SUBJECT: COMANCHE PEAK NUCLEAR POWER PLANT, UNITS 3 AND 4
DOCKET NUMBERS 52-034 AND 52-035
RESPONSE TO REQUEST FOR ADDITIONAL INFORMATION NO. 3183

Attachment 1. Response to Request for Additional Information No. 3183 (CP RAI #88)

SRP SECTION: 13.03 - Emergency Planning

Figures E-1 through E-7
Replace Figures E-1
through E-3 in Appendix E
RAI No. 3183
13.03-22

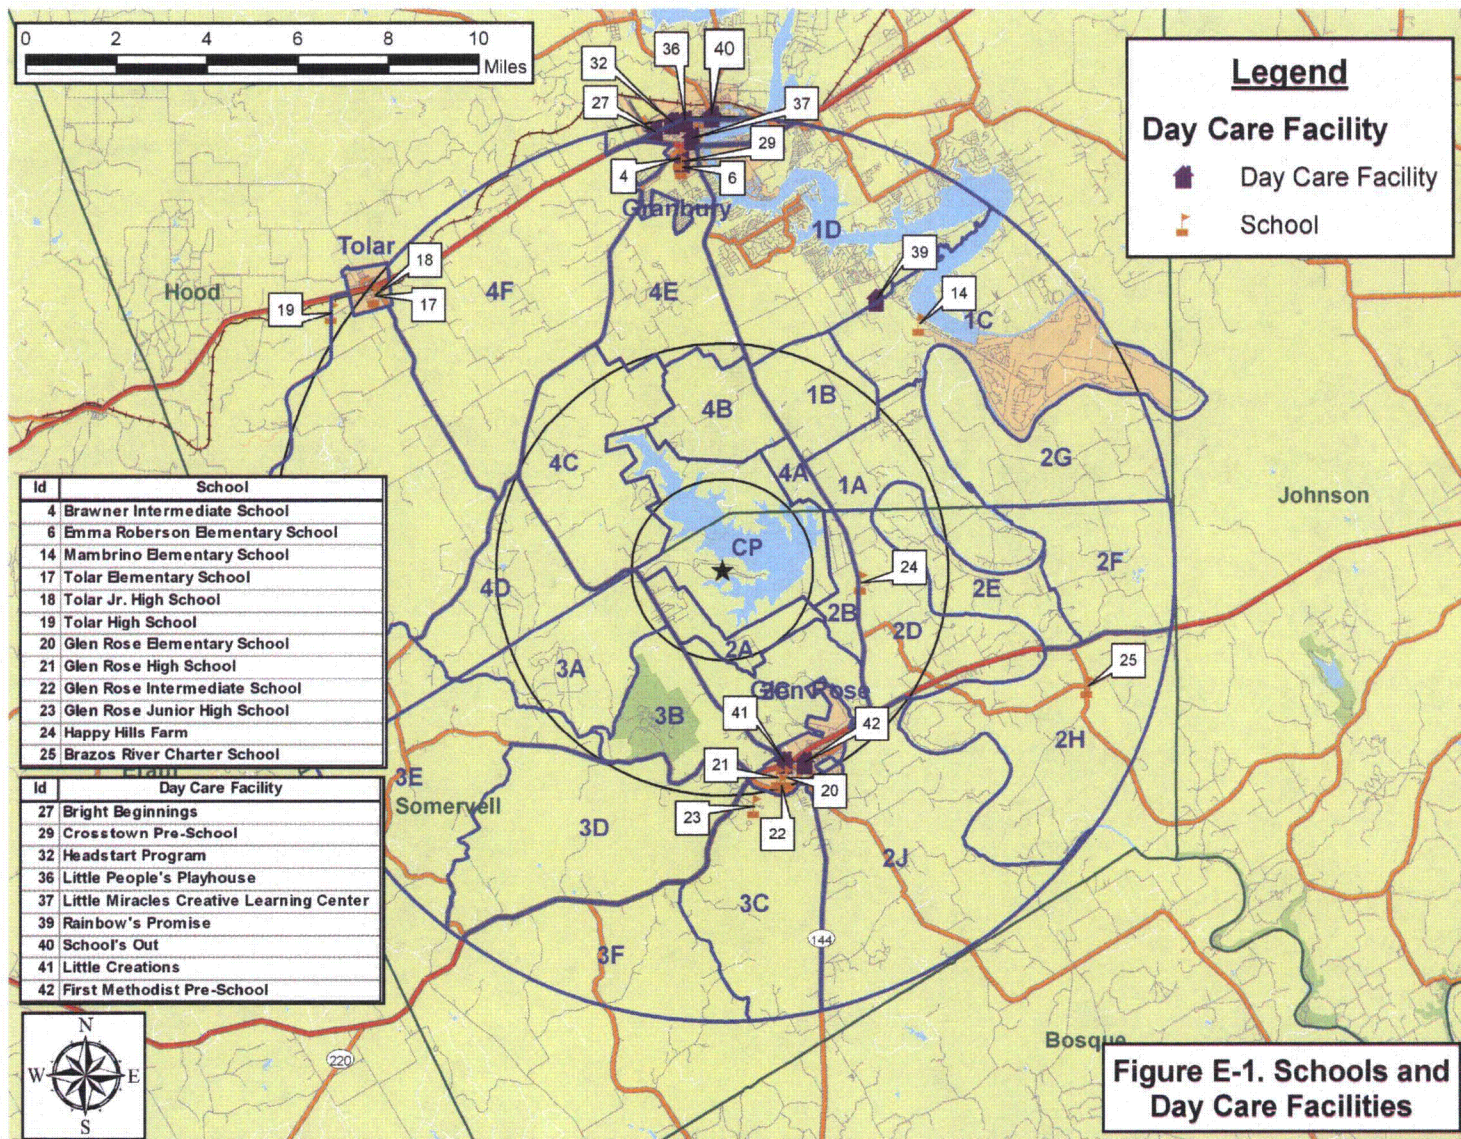
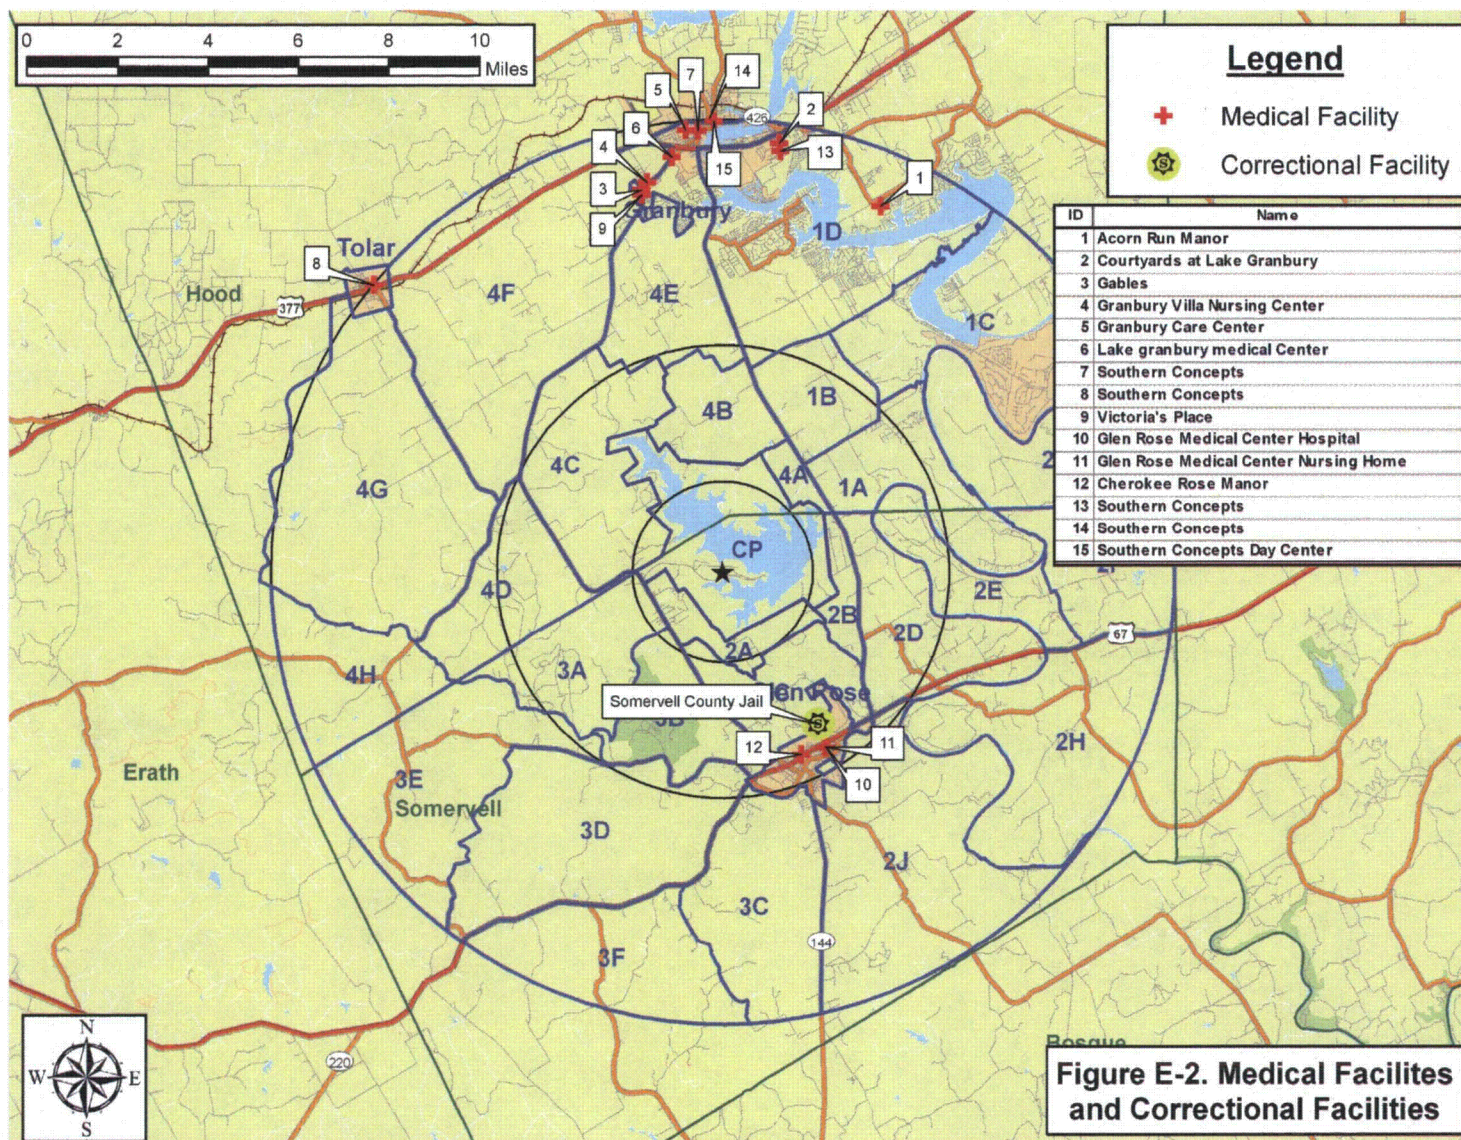
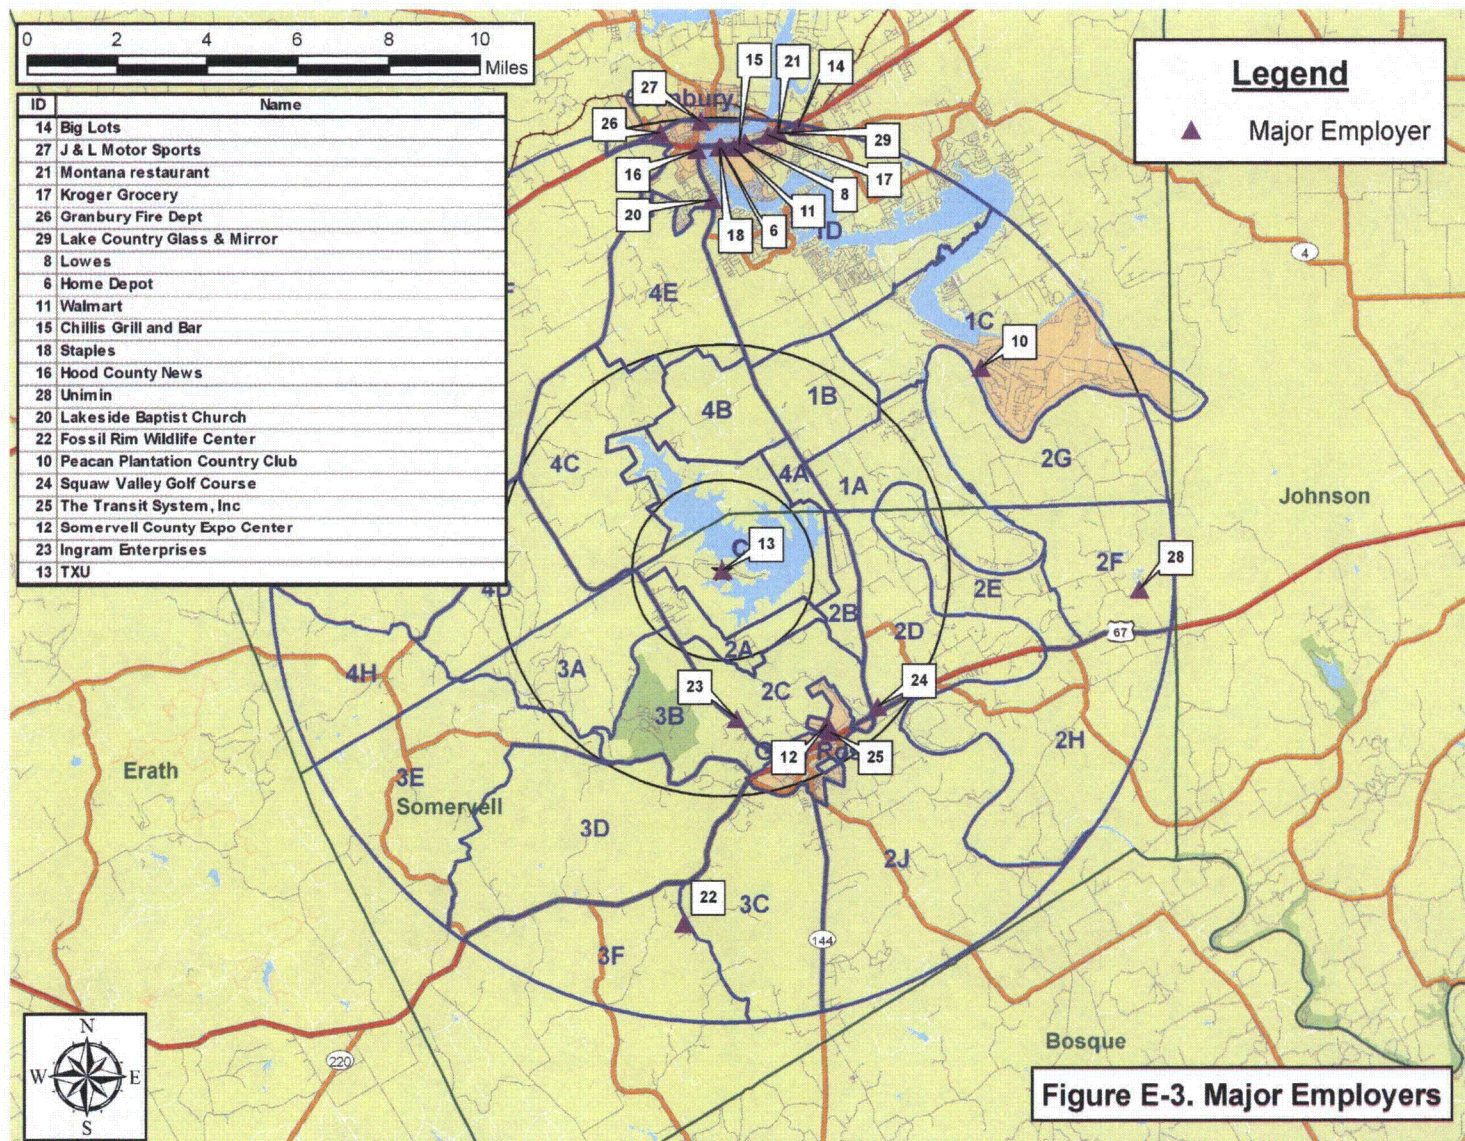
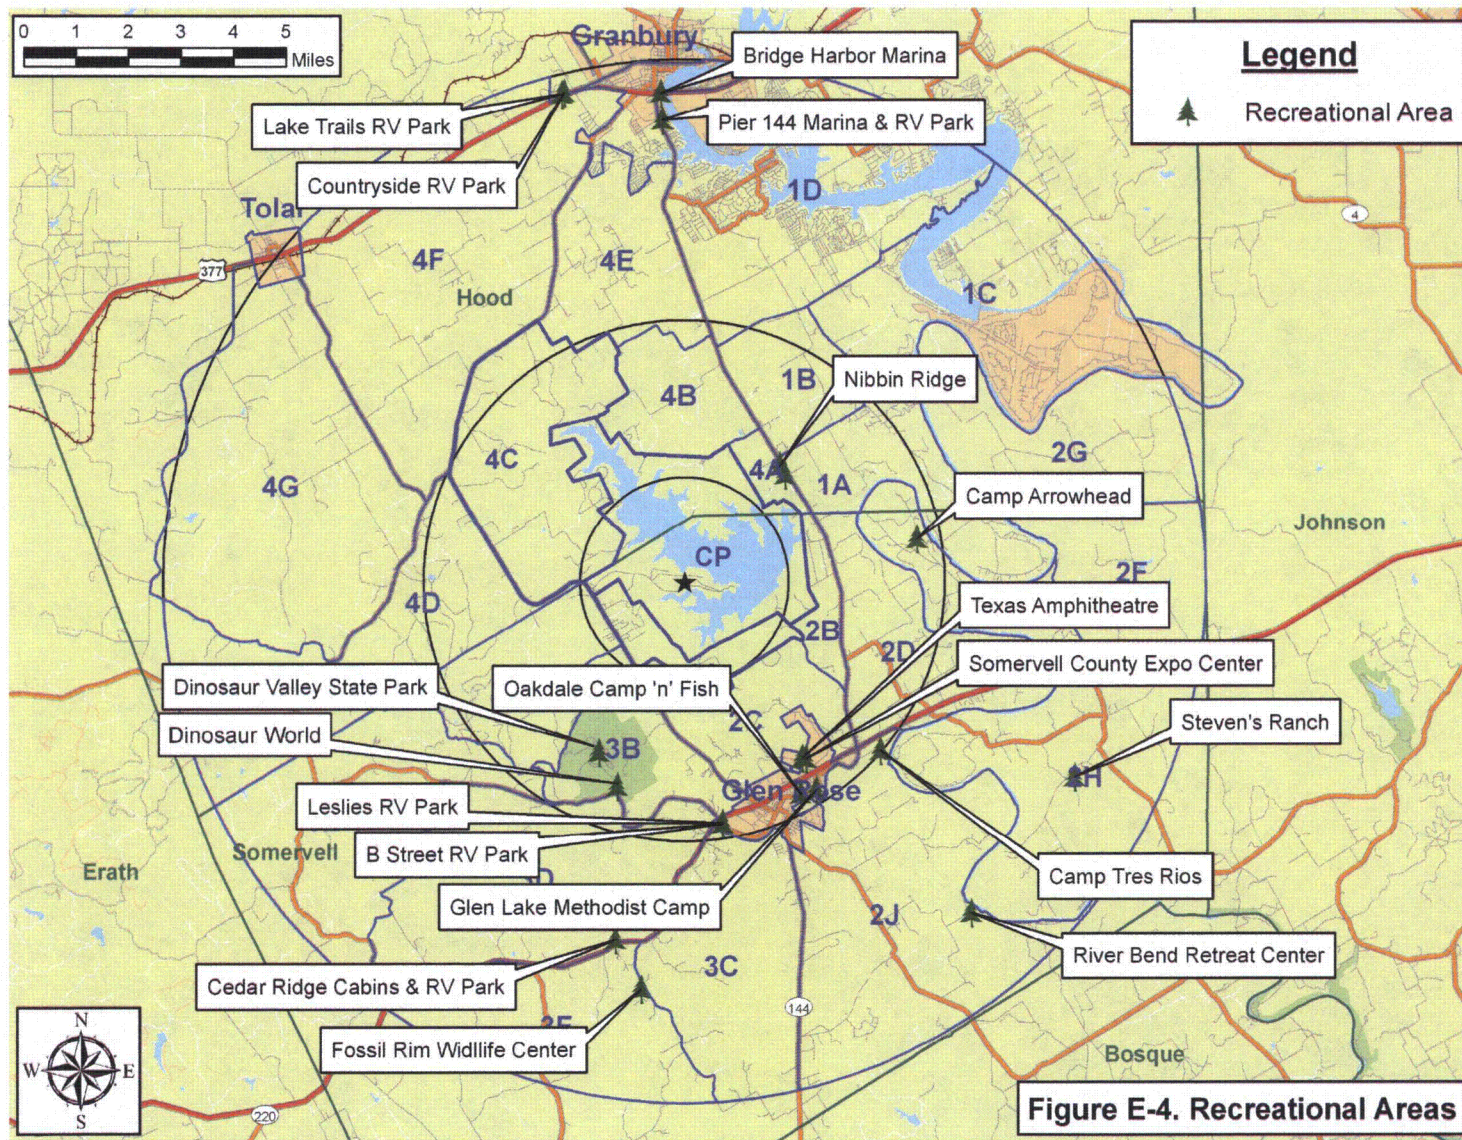
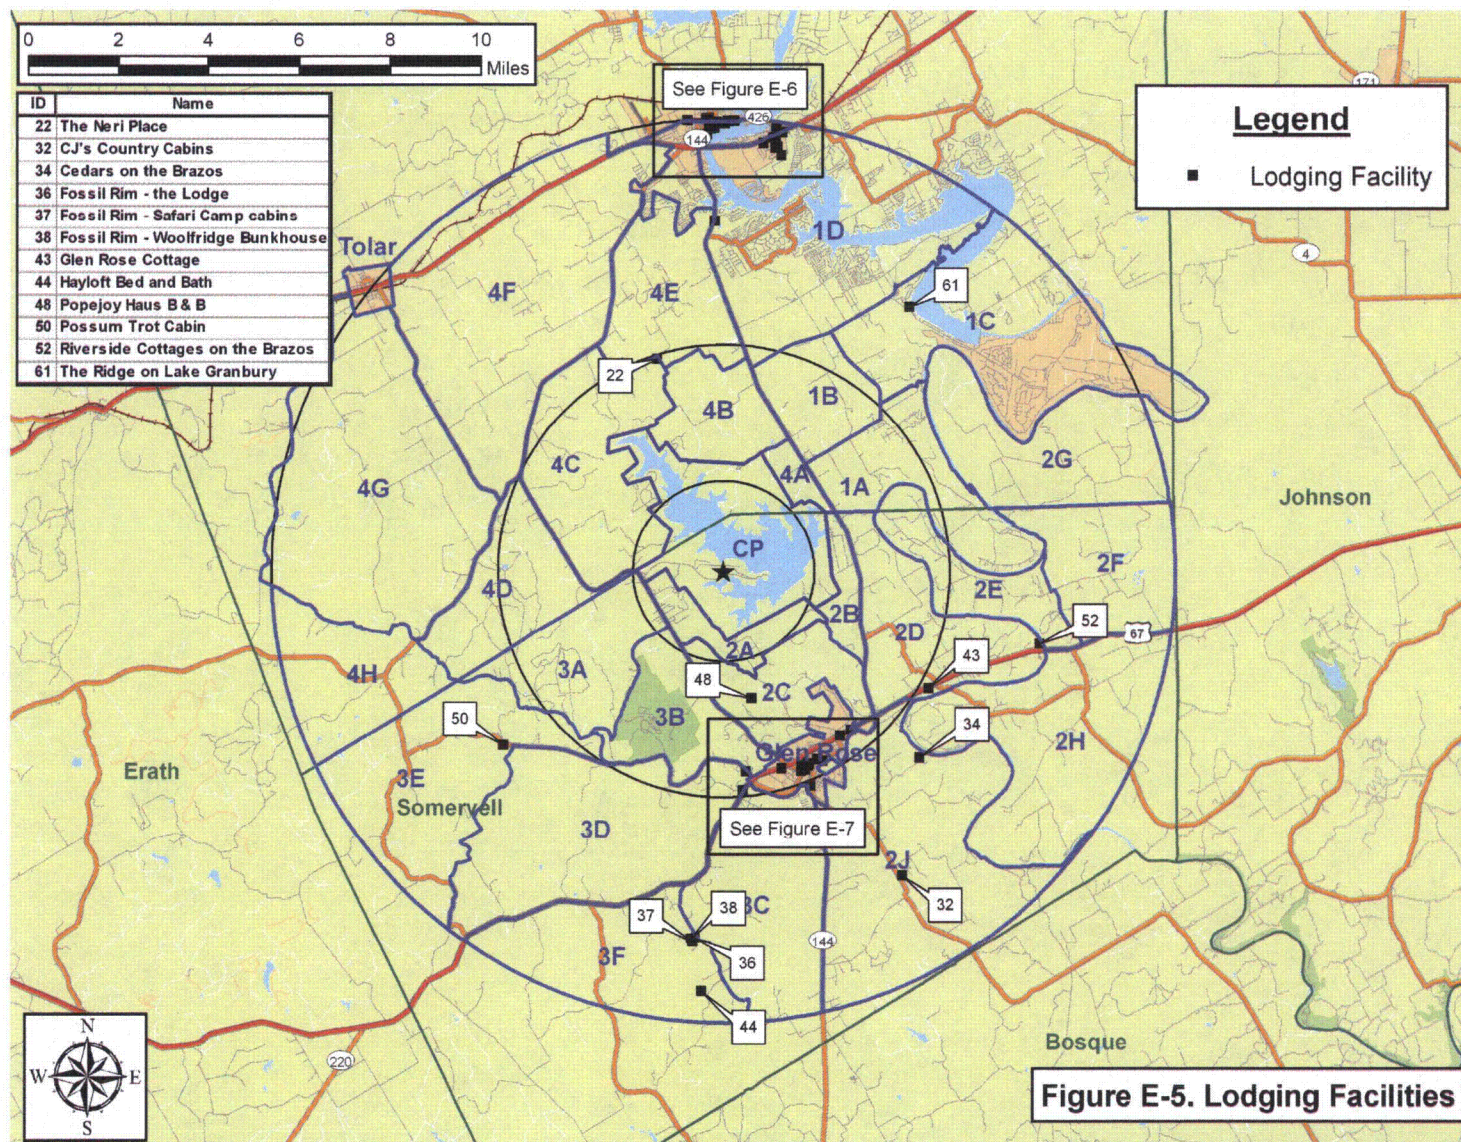
- Added new Figure E-1 which maps the schools and day care facilities in the EPZ.
 - Added new Figure E-2 which maps the medical and correctional facilities in the EPZ.

- Former Figure E-1, which identifies the major employers in the EPZ was re-numbered as Figure E-3. Also, labels identifying each of the major employers was added.

- Former Figure E-2, which identifies the recreational areas in the EPZ was re-numbered as Figure E-4.
 - Former Figure E-3, which identifies the lodging facilities in the EPZ was re-numbered as Figure E-5. Also, labels identifying each of the lodging facilities were added. Due to the high density of lodging facilities in Granbury and Glen Rose, insets were drawn around these areas in Figure E-5. Maps of these inset areas are added as Figures E-6 and E-7 for Granbury and Glen Rose, respectively.
